**STAFF REPORT**  
**COMMUNITY DEVELOPMENT DEPARTMENT**

SUBJECT: H-2020-0005  
 Landing South – ~~RZ~~, PP

LOCATION: 660 S. Linder Rd. (Parcel #S1213233965; NW ¼ of Section 13, T.3N., R.1W.)

C. Landscape Plan (date: 5/29/2020 10/5/2020)

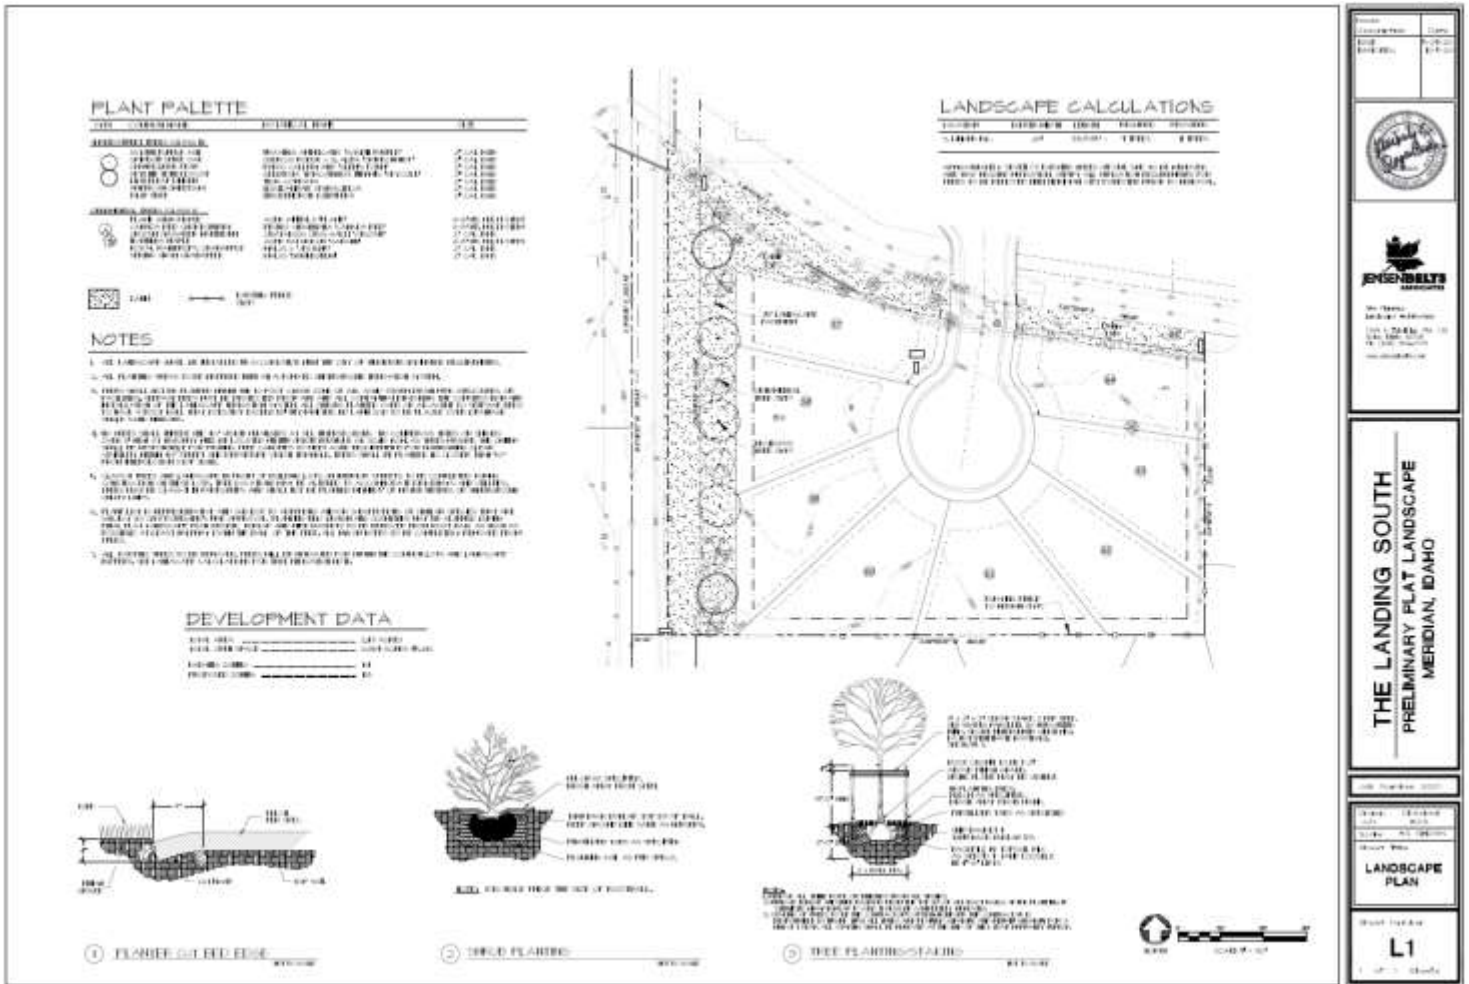
A 25-foot wide street buffer (measured from back of sidewalk) is required adjacent to N. Linder Rd., an arterial street, landscaped per the standards listed in [UDC 11-3B-7C](#), which require buffers to be planted with a mix of trees and shrubs, lawn, or other vegetative groundcover. Just lawn and trees are proposed; **Staff recommends shrubs are added at a minimum.**

**There are several existing trees on this site that are proposed to be removed with development that require mitigation per the standards listed in UDC 11-3B-10C.5. The City Arborist inspected the site and determined an additional 67 caliper inches of trees need to be provided on the site for mitigation. The 50-inch caliper silver maple along Linder Rd. is required to be retained on the site and protected during construction, unless required to be removed by ACHD. Mitigation calculations should be included in the Landscape Calculations table demonstrating compliance with the aforementioned UDC standard.**

All fencing is required to comply with the standards listed in UDC 11-3A-7. Fencing exists along the south and east boundaries of the site that is proposed to remain. No new fencing is proposed on the landscape plan. **Fencing is required to be constructed by the Developer adjacent to common open space lots to distinguish common from private areas as set forth in UDC 11-3A-7A.7a. The Applicant states that wrought iron fencing will be constructed at the back edge of the street buffer along Linder Rd. and along the Kennedy Lateral easement at the north boundary of the site; fencing should be depicted on the landscape plan accordingly.**

- d. Note #2 – “. . . It is being rezoned as R-8 Medium Density Residential District.”
3. The landscape plan included in Section VIII.A.3, dated ~~5/29/2020~~ 10/5/2020, shall be revised as follows prior to submittal of the final plat application:

- a. Depict wrought iron fencing as proposed by the Applicant along common open space lots to distinguish common from private areas in accord with UDC 11-3A-7A.7a.

- b. Depict an additional 67 caliper inches of trees within common areas on the site as mitigation for removal of existing trees in accord with the standards listed in UDC 11-3B-10C.5. The 50-inch caliper silver maple along Linder Rd. is required to be retained on the site and protected during construction, unless required to be removed by ACHD.

- c. Include mitigation calculations in the Landscape Calculations table based on the City Arborist’s inspection, in accord with the standards listed in UDC 11-3B-10C.5; a total of 67 caliper inches of trees is required for mitigation.

- d. Depict shrubs within the street buffer as set forth in UDC 11-3B-7C.3a.
4. Future development shall be consistent with the minimum dimensional standards listed in [UDC Table 11-2A-5](#) for the ~~R-8~~ R-4 zoning district.

D. Open Space Exhibit (dated: ~~May 28, 2020~~ October 5, 2020)

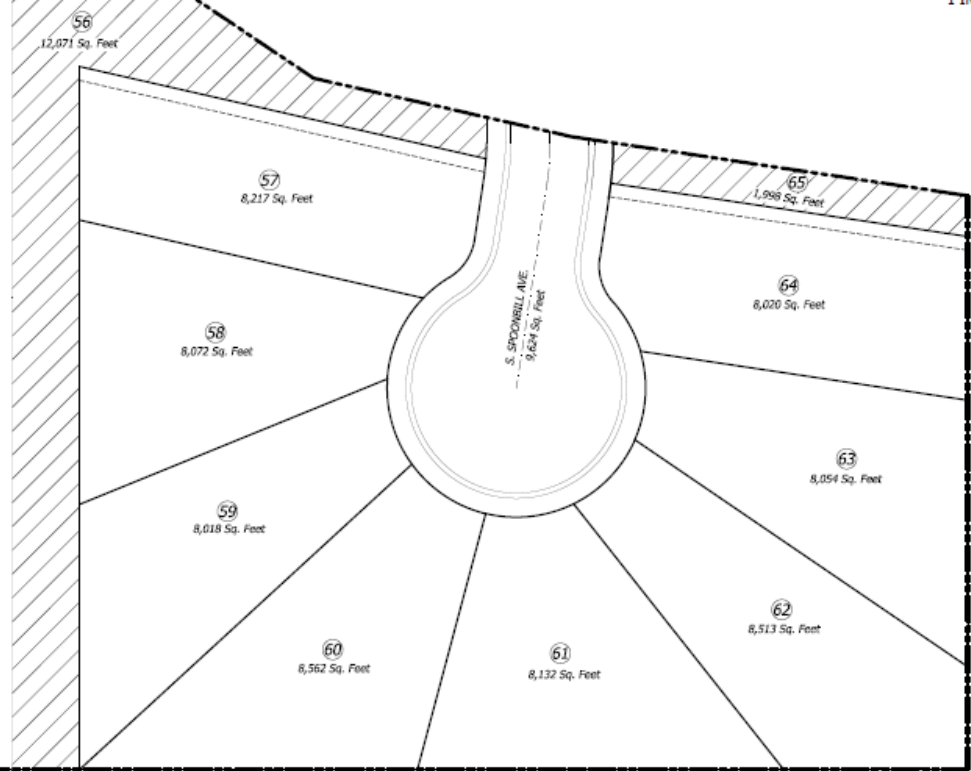
A minimum of 10% *qualified* open space meeting the standards listed in UDC 11-3G-3B is required for developments over 5 acres in size; because this property is only 2.27 acres, this standard does not apply. However, the Applicant did submit an open space exhibit that depicts ~~0.37~~ 0.32 of an acre of common open space including street buffer along Linder Rd. and area along the north boundary of the site where the Kennedy Lateral is located.
